**STAFF REPORT
KETCHUM PLANNING AND ZONING COMMISSION
OCTOBER 14, 2025 MEETING**

PROJECT: Swan Stream Alteration

FILE NUMBER: P24-057

REQUEST: Floodplain Development Permit for stream alterations to enhance river and floodplain function and rehabilitation of riparian areas.

AREA 4 SITE PLAN

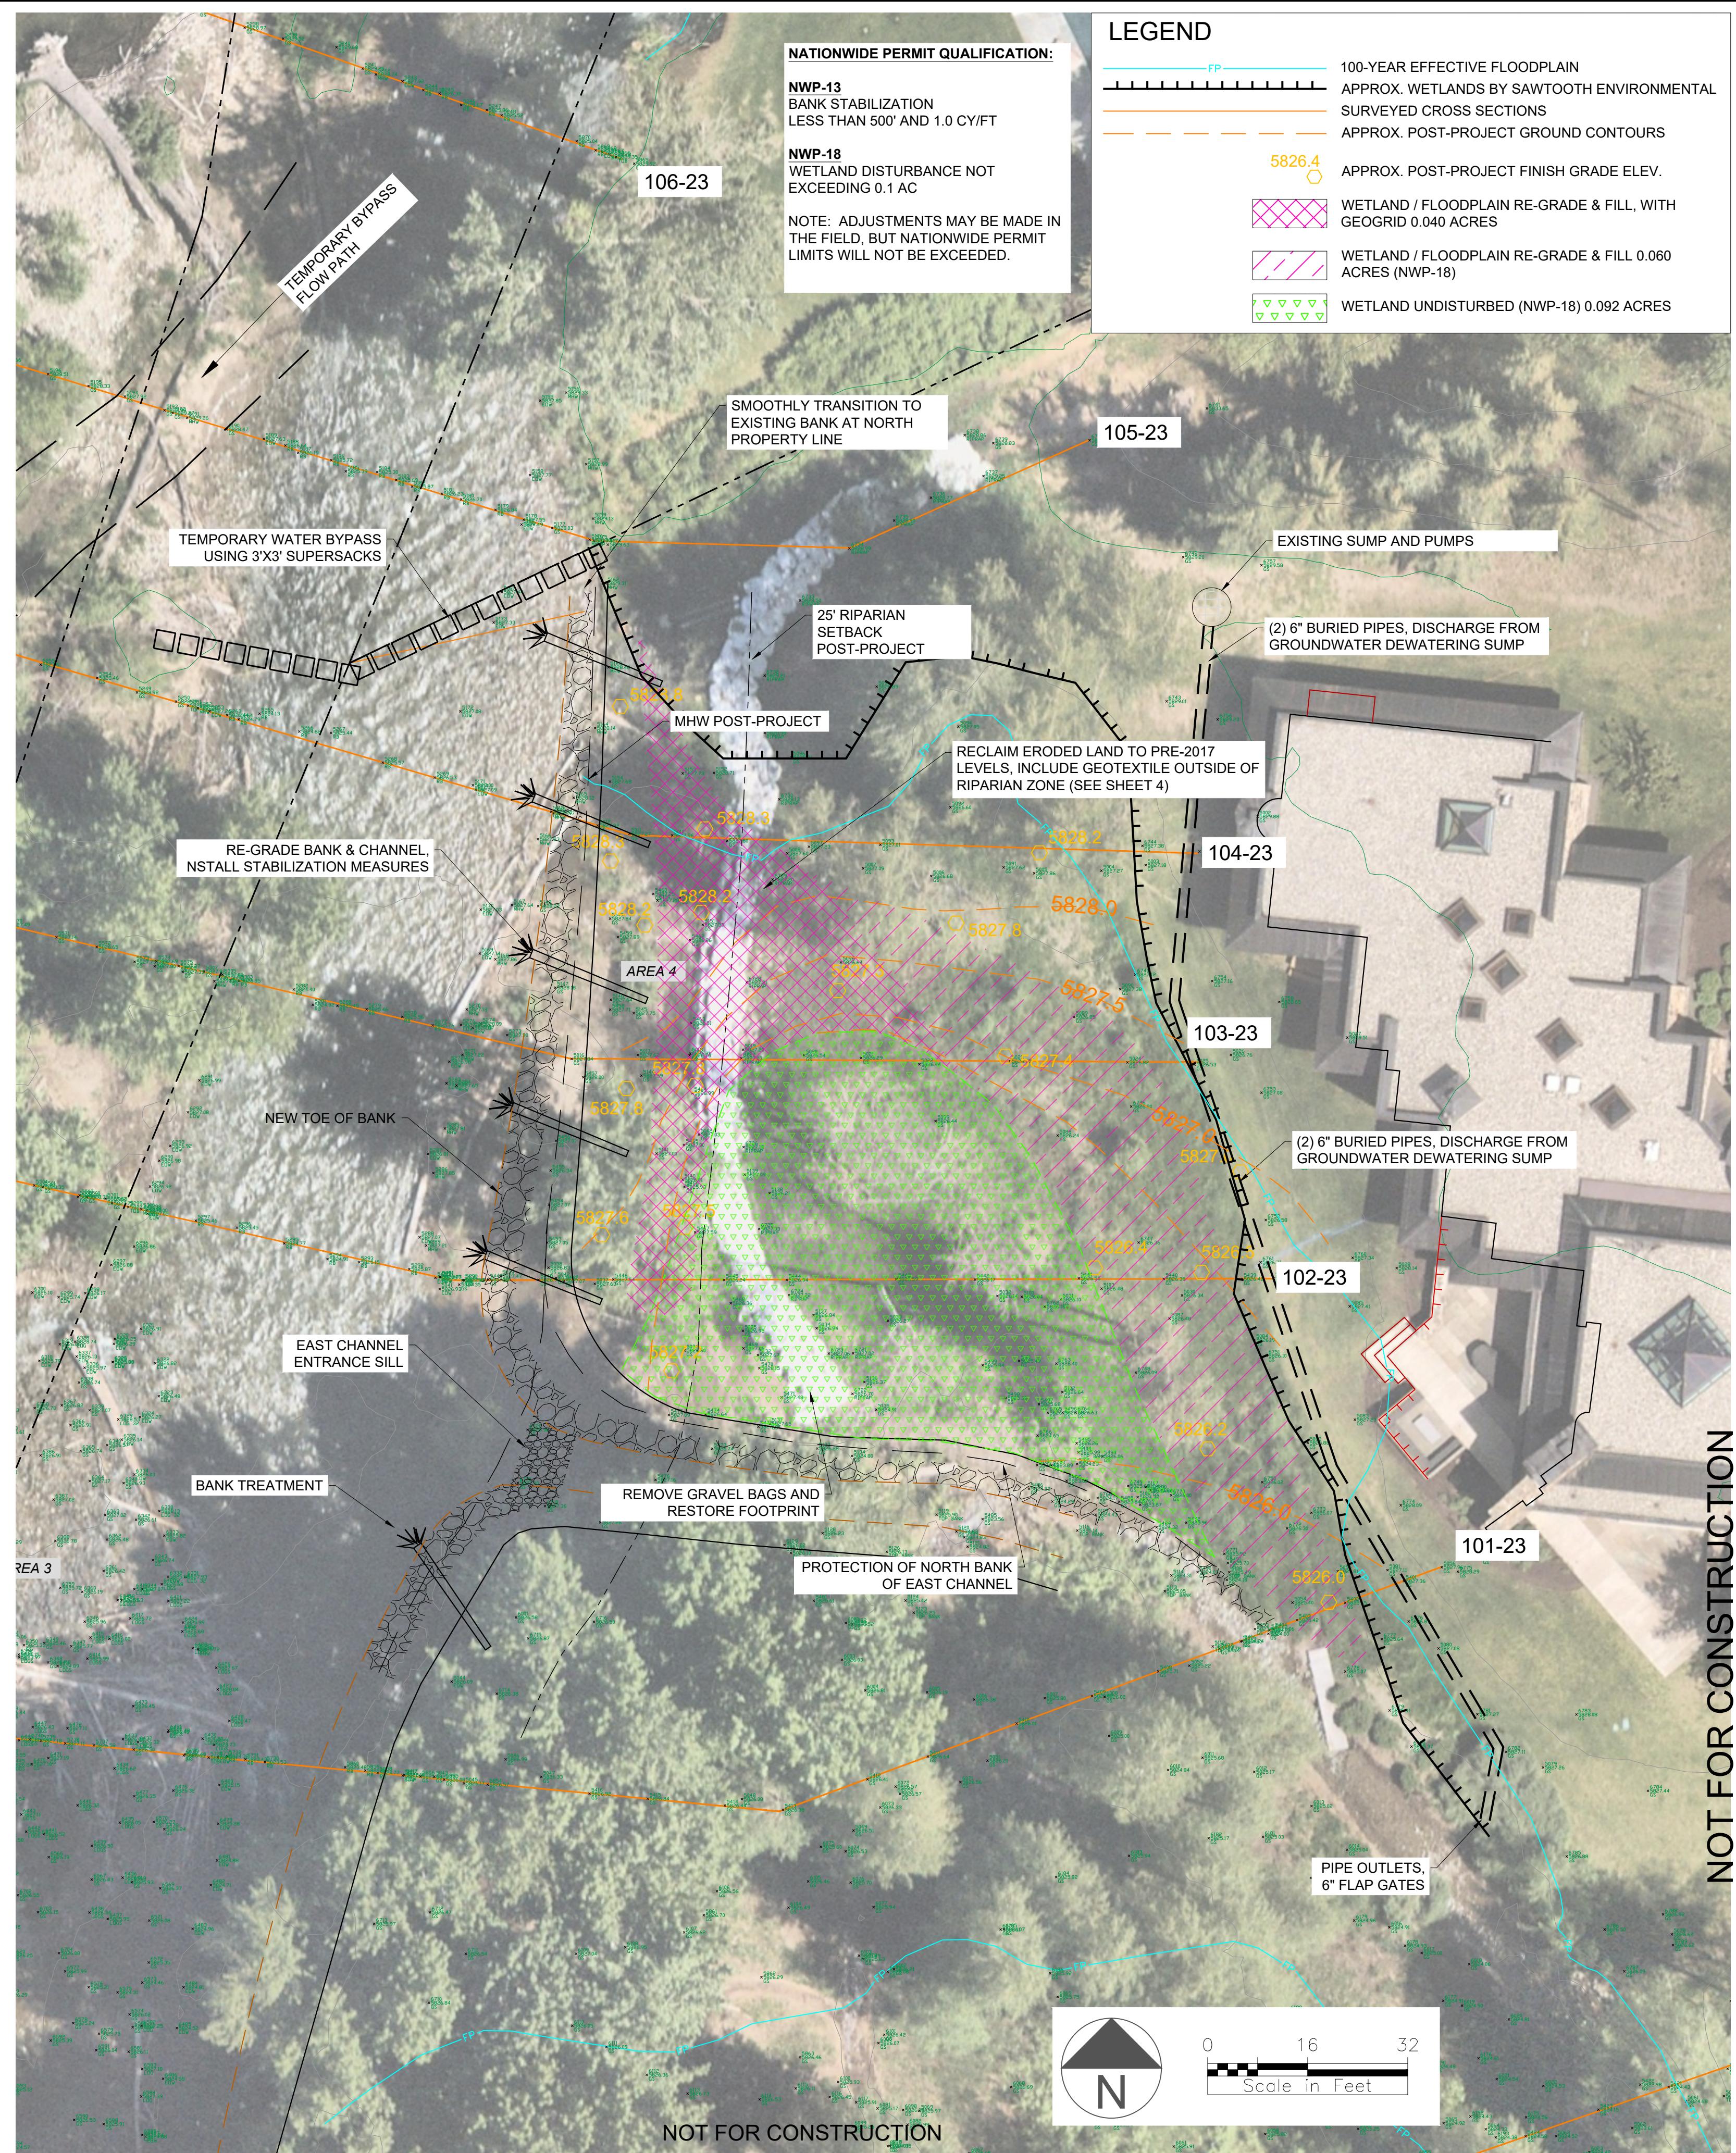
Staff does not believe this amount of topsoil is sufficient to promote adequate revegetation. Staff also has concerns of the material remaining in place during spring runoff events and daylighting geogrid material, which would not comply with the floodplain development criteria. Staff has included recommended conditions of approval related to the proposed planting plan in the report below. In addition to those recommendations, the following condition of approval is recommended:

The landscape plan provided in the application materials was submitted with the initial application and has not been updated to reflect the proposal outlined above. The planting proposed within the wetland fill area includes some shrubs but consists primarily of Scottish Links fescue, which is a turf grass commonly used in golf course applications. Although drought tolerant and known to be very hardy, staff does not believe the proposal to be an appropriate planting choice. Blaine County has an approved Riparian and Wetland Planting List (Attachment E) that recommends plant species based on location and inundation conditions present. The City of Ketchum does not have a separately adopted plant list, and relies on the Blaine County list for guidance on how to achieve high quality riparian and wetland restoration.

- The applicant shall install the geogrid material at a depth that provides a minimum of eight inches of topsoil in all locations. 12 inches of topsoil is preferred to better support the revegetation of the disturbed areas. The applicant shall conduct an additional analysis and provide such to the Planning and Building Department for review, to determine if 12 inches of topsoil can be placed without jeopardizing the No Rise and No Adverse Impact certifications currently achieved by the project. Based on the results of the analysis, staff may require additional topsoil be placed in key areas to increase success rates for revegetation and bank stability.

- The applicant shall revise the landscape plan dated June 7, 2024 to reflect the Commission approved extents of wetland fill and revise the planting plan to reflect a mix of appropriate shrubs and grasses outlined in the 2021 Blaine County Wetland and Riparian Plant List for “Dry Riparian” areas. The revised plan shall be provided to the Planning and Building Department for final review and approval prior to any installation.
- The landscape plan shall be revised to include information regarding the protection and irrigation of the disturbed and revegetated areas to ensure success rates are achieved. Irrigation shall be provided, either permanently or temporarily, for a minimum of two growing seasons. Permanent irrigation is not permitted within the 25-foot riparian zone.

2 **BANK TREATMENT - MAIN RIVER**
1 2 SCALE: N.T.S.

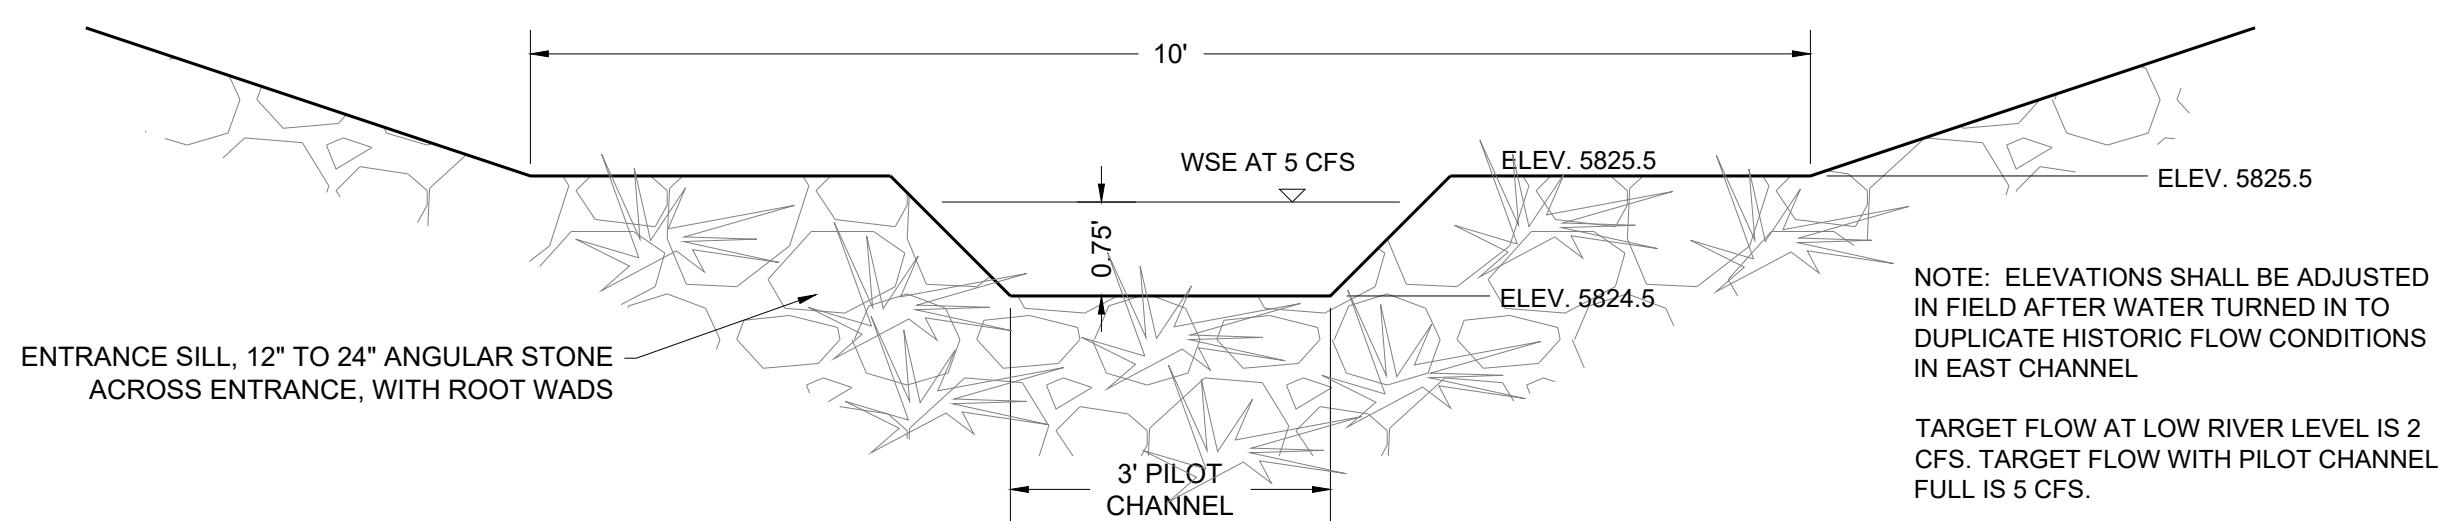
In general, staff is supportive of the stream alteration and bank stabilization proposed for the project, however, staff believe that additional consideration of the planting plan within the riparian area is warranted. The application narrative provides an overview of the planting plan, planting methods, and coverage targets for the various zones, including two zones specific to the riparian area. Zone #2 is the area within the 25-foot riparian area between the ordinary mean high-water mark and the 25-foot boundary. Zone #3 is the area from the ordinary mean high-water mark down to the toe of the channel.

Healthy riparian areas are characterized by a hierarchy of plants (grasses, shrubs, and trees) of varying species creating a dynamic biodiverse environment that enhances habitat areas for aquatic and avian species, stabilizes riverbanks, and promotes improved water quality. This stretch of the Big Wood River is a specific microclimate with significant shade and habitat refuge. Trees are a critically important and prevalent species on this stretch of the Big Wood as they provide shade and habitat refuge. The proposed planting plan for Zones #2 and #3 are limited to riparian grasses and shrubs with no proposed trees and low planting densities. Additionally, the planting method proposes to install grasses through a hydroseed method that is not always successful in riparian or floodplain applications. Finally, the proposed seed mixes for the riparian area are drought tolerant and hearty, but not specific to riparian areas.

- Include a minimum of five trees within Zone #2 of a species identified in the Blaine County Wetland and Riparian Plant List appropriate for the zone immediately behind the streambank. The landscape plan shall also be revised to increase the planting density of shrubs within Zone #2 area from six per 1,000 SF to 10 per 1,000 SF.

- Include a minimum of five trees within Zone #3 of a species identified as bank stabilizers in the Blaine County Wetland and Riparian Plant List. Cottonwood trees located at the top of the slope are preferred, however, other species may be considered. Grouping of trees may be appropriate provided the locations of trees are strategically placed to maximize bank stabilization at key pressure point locations (south end of bank stabilization).

- Propose a new grass mix for the riparian area with species identified in the Blaine County Wetland and Riparian Plant List for undergrowth grasses and forbs in riparian areas. The landscape plan shall also be revised to propose an alternate planting method for grasses such as hydro mulch, intermittent plug planting, or other methods with greater success rates in riparian areas.

- Identify temporary fencing requirements for trees and shrubs for a minimum of three growing seasons to ensure adequate success rates of plantings.
